Suitland Garage Expansion Joint RFI's 001 and 002

Project: 4600 Silver Hill Road

Subject: Concrete at Expansion Joint Condition

CINNOVAS		Suitland Garage Expansion Joint Replacement— Request For Information (RFI)	
RFI Number:	3	Due Date:	11/13/2020
Subject:	Walter P Moore Design Solution to Tapered Edges	Status:	Open
Assignees:	Andre Thomas	Ball In Court:	Andre Thomas
RFI Manager	(b) (6)	Distribution List:	N/A
Created By:	(b) (6)	Date Initiated:	11/6/2020
Received From:	N/A	Responsible Contractor:	Cinnovas
Drawing Number:	N/A	Location:	Suitland Federal Center
Spec Section:	N/A	Cost Code:	N/A
RFI Stage:	Course of Construction	Reference:	N/A
Schedule Impact:	TBD	Private:	No
Cost Impact:	TBD		
Question:	As follow-up, can GSA please let us know if the attached design solution will be acceptable to correct the out-of-square existing conditions of the garage concrete slab edges so that the Emseal expansion joint material can be installed per the manufacturer?		
Response:

Author RFI No.001

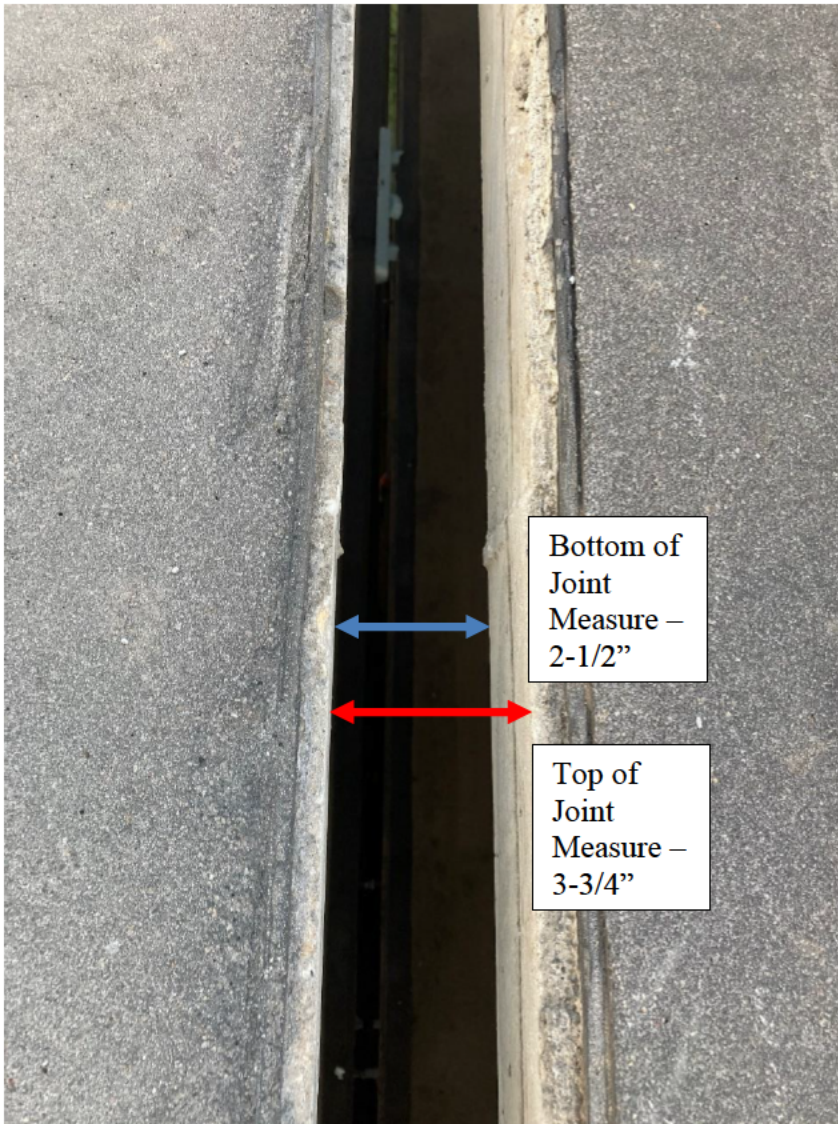
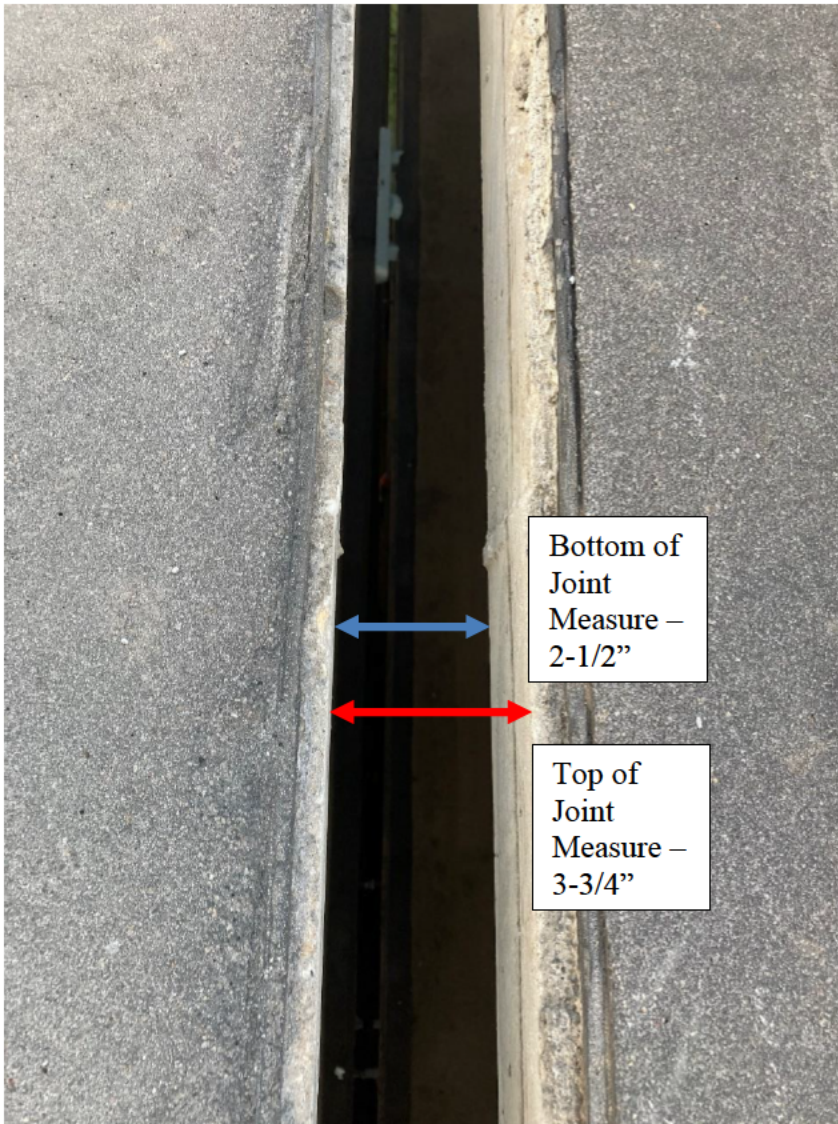
After removing existing expansion joint materials, preparing the joint we realized that the "throat" of the joint is not a linear concrete slab edge, and in fact the concrete at various areas of a typical joint angles back in towards the center of the slab. Which is preventing Atlantic from installing the expansion joint as intended per manufacture direction. In order to properly install the expansion joint, Atlantic will need to modify the edge of the concrete substrate. By modifying the concrete to an even linear space between the two slabs the expansion joint will be able to move and flex with the structure as intended. Please see attached pictures and drawings to help further understand.

Can you please confirm this is an acceptable solution to the issue at bay.

Modifying the edge of the concrete substrate is acceptable however; be cautious not to cut or interfere any existing slab rebar.

In addition, a registered professional structural engineer needs to provide a letter confirming this slab modification will not affect the overall existing slab integrity and load capacity

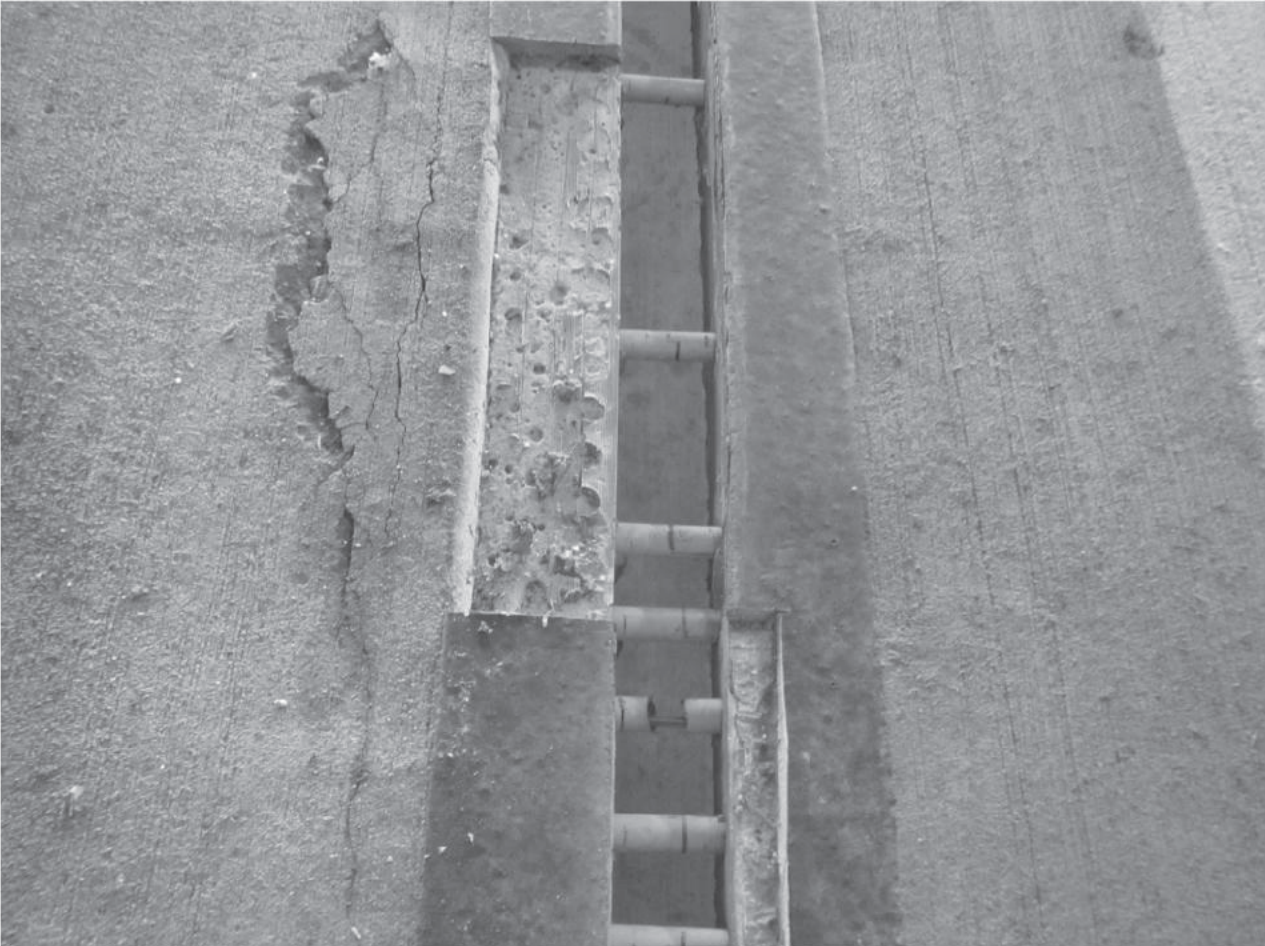
There is existing electrical conduit running through the expansion joint. In order to make the modifications to the concret that supports the expansion joint Atlantic is requesting that the power be shut off while demoing around the conduits. Can you please confirm if the power can be shut off to the garage during the demolition?

1. ALL REROUTED ELECTRICAL CONDUITS TO MATCH EXISTING UNDERSIDE CONDUITS, AS SHOWN IN PHOTO.

1. EMBEDDED ELECTRICAL CONDUITS ARE PRESENT IN THE EXISTING CONCRETE SLAB, IN ADDITION TO PT TENDONS. VERIFY LOCATION PRIOR TO COMMENCEMENT OF WORK
2. COORDINATE WITH OWNER TO LOCATE EXISTING CONDUIT TO BE REMOVED AND CUT FLUSH WITH SLAB EDGE.
3. COORDINATE WITH OWNER TO REROUTE ELECTRICAL CONDUIT TO UNDERSIDE OF CONCRETE BEAMS, AS PER EXISTING.
